**REGULAR MEETING OF THE PLANNING BOARD
WEDNESDAY, JULY 26, 2017
7:30 PM
CITY COMMISSION ROOM
151 MARTIN STREET, BIRMINGHAM**

**CITY OF BIRMINGHAM
PLANNING BOARD ACTION ITEMS
OF WEDNESDAY, JULY 12, 2017**

SUBJECT: 375 S. Eton – The District Lofts
Final Site Plan & Special Land Use Permit Review – District Lofts Building B

Building Section

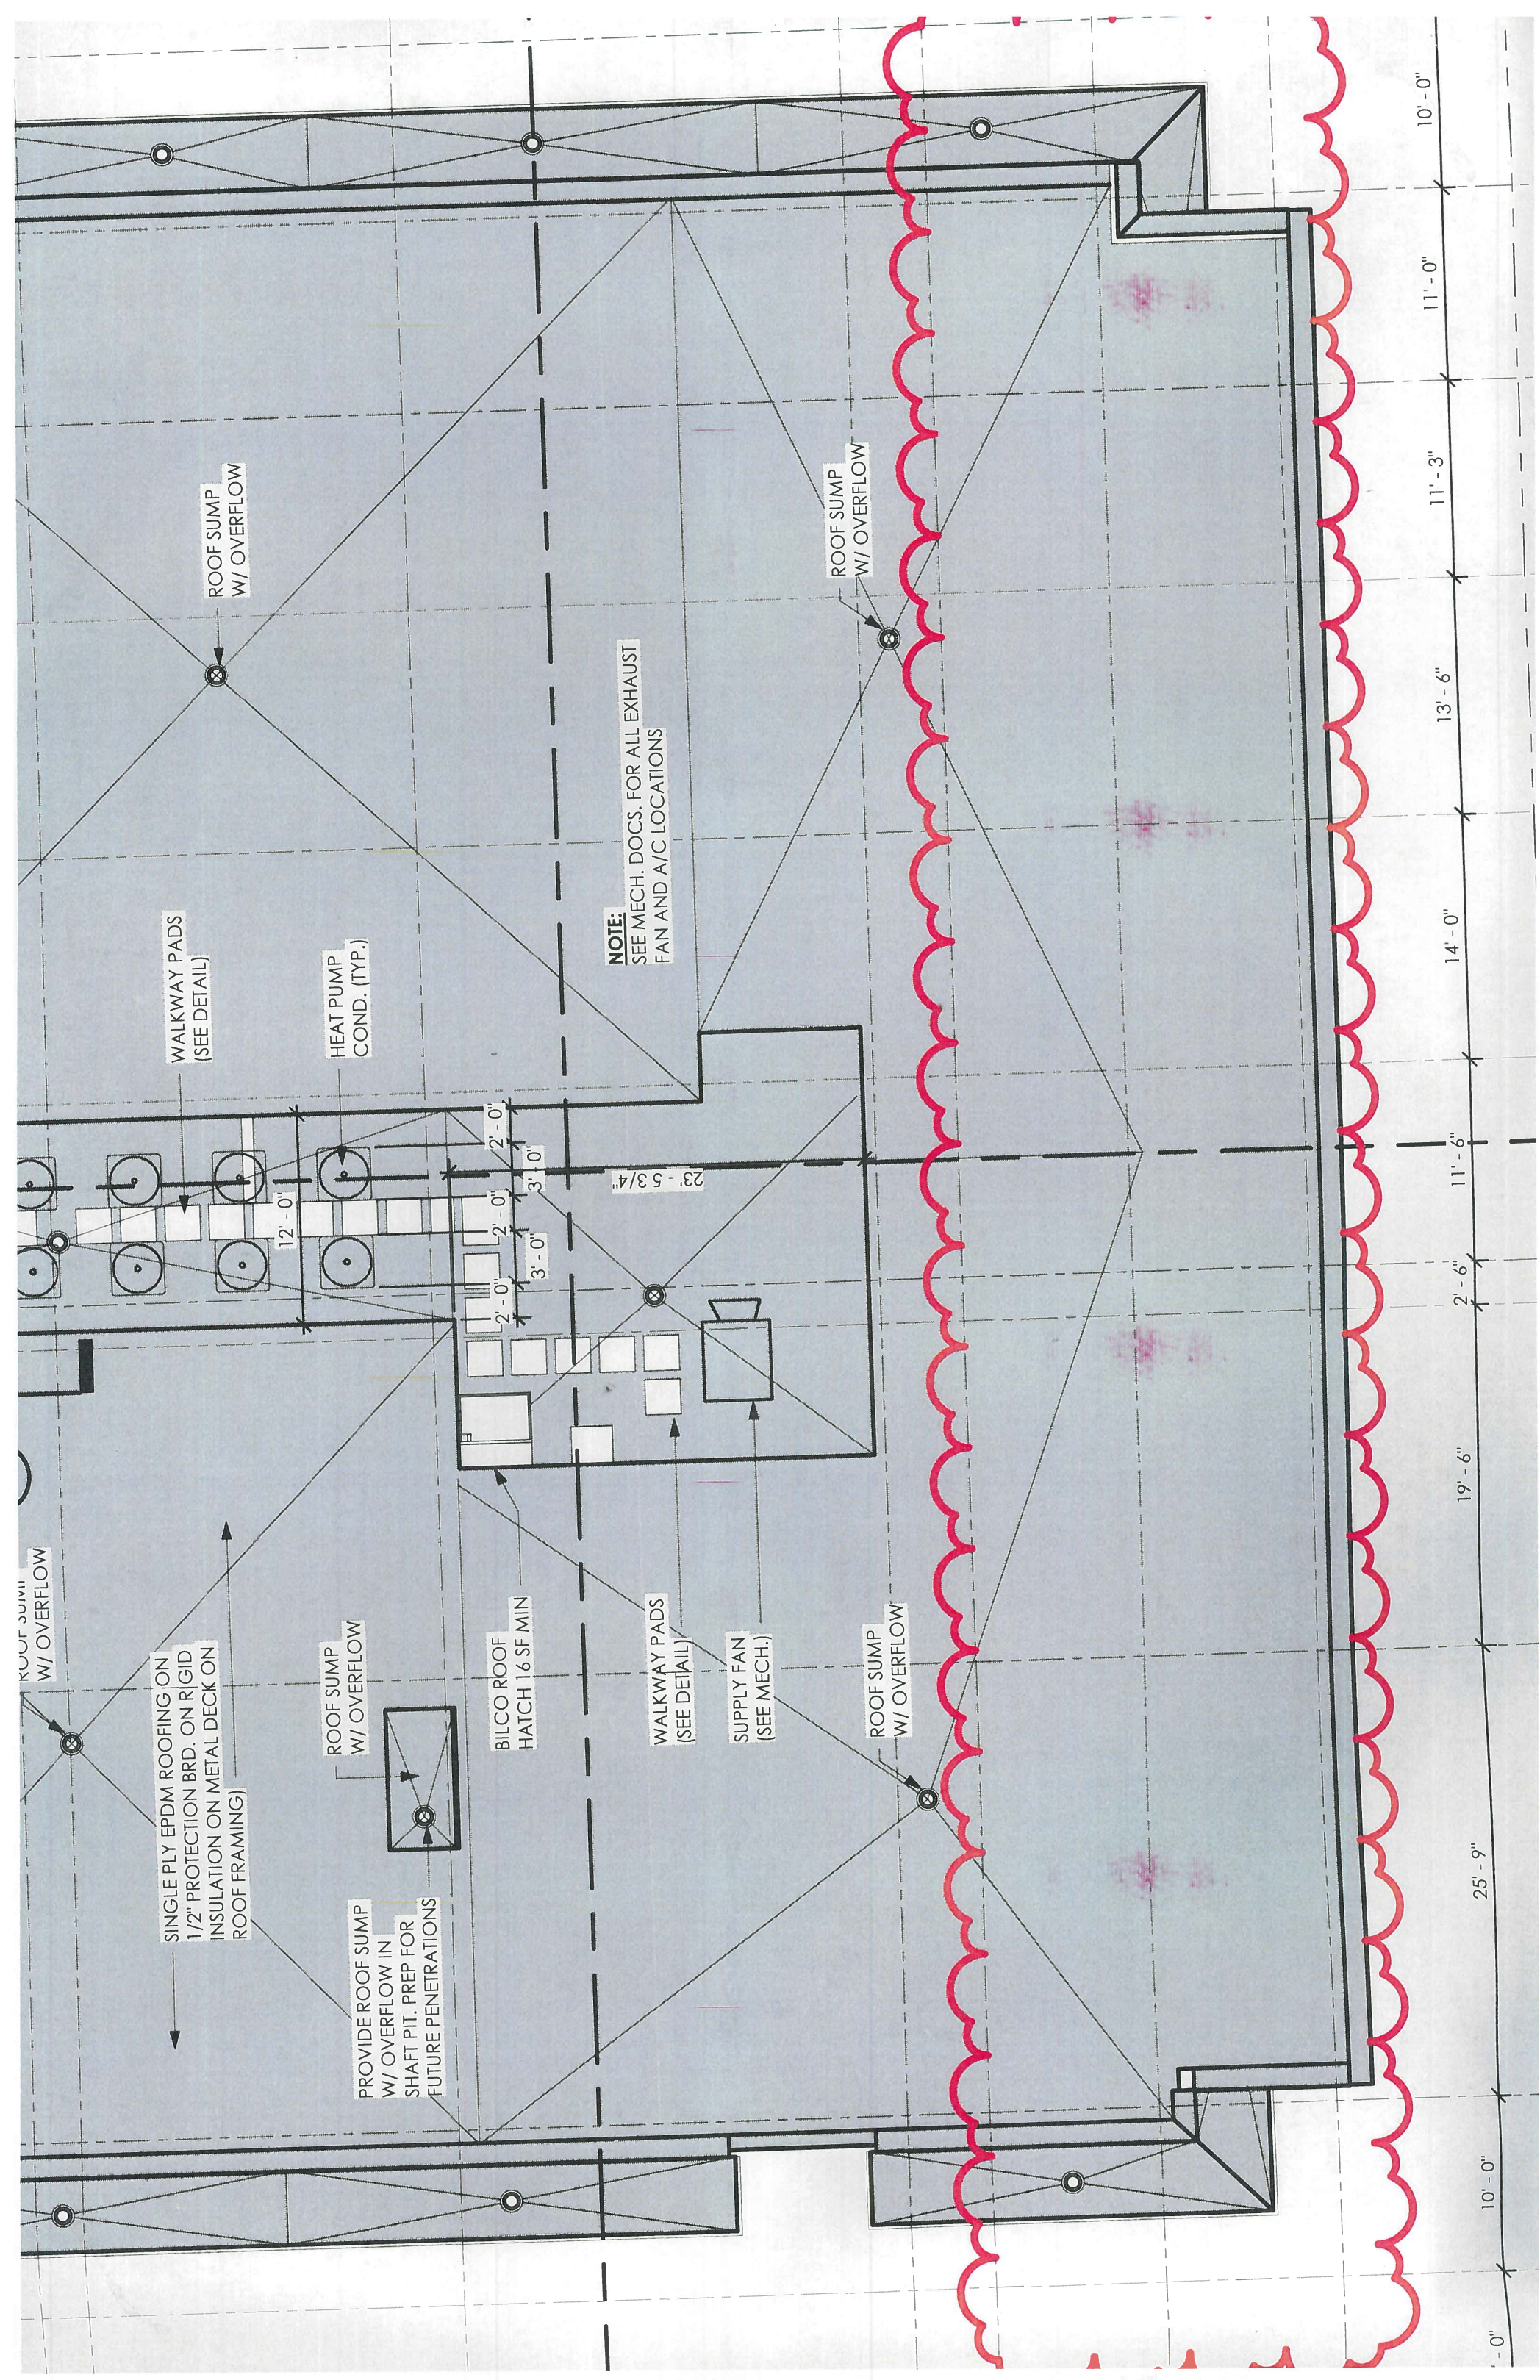
- The building plans show exterior work for the northeast elevation and north elevation at the patio. **The Planning Division cannot approve any of this work as the Final Site Plan does not demonstrate work on these portions of the North Elevation.** Request for administrative approval to allow exterior work on Northeast and North elevations at the patio. Sheet A.201

- The north elevation shows 4 unapproved "Residential Light Sconces." **The applicant will be required to obtain Administrative Approval for all proposed light fixtures.** Request for administrative approval for proposed lighting schedule and locations. Sheet A.201

- The right portion of the north elevation is almost completely devoid of windows and does not match the approved Final Site Plan. **The applicant must revise these drawings to demonstrate the proper calculation methods were used and that the glazing requirements continue to be met.**
Window and glazing calculations meet requirements for Downtown Birmingham Overlay District, Window standards for Zone B2B, and ICC 705.8 Allowable Openings for Exterior Walls. Sheet A.201

- The architectural component that runs vertically on the center of the elevation as shown in the approved Final Site Plan is completely devoid of any architectural accenting in the building plans. **The applicant will be required to obtain Administrative Approval for these changes.**
Request for administrative approval to remove architectural accenting from vertical component in center of elevation. Sheet A.201

- Request for administrative approval to reduce second story windows to 44 panes in 18 casements. Window and glazing calculations meet requirements for Downtown Birmingham Overlay District, Window standards for Zone B2B, and ICC 705.8 Allowable Openings for Exterior Walls. Sheet A.201
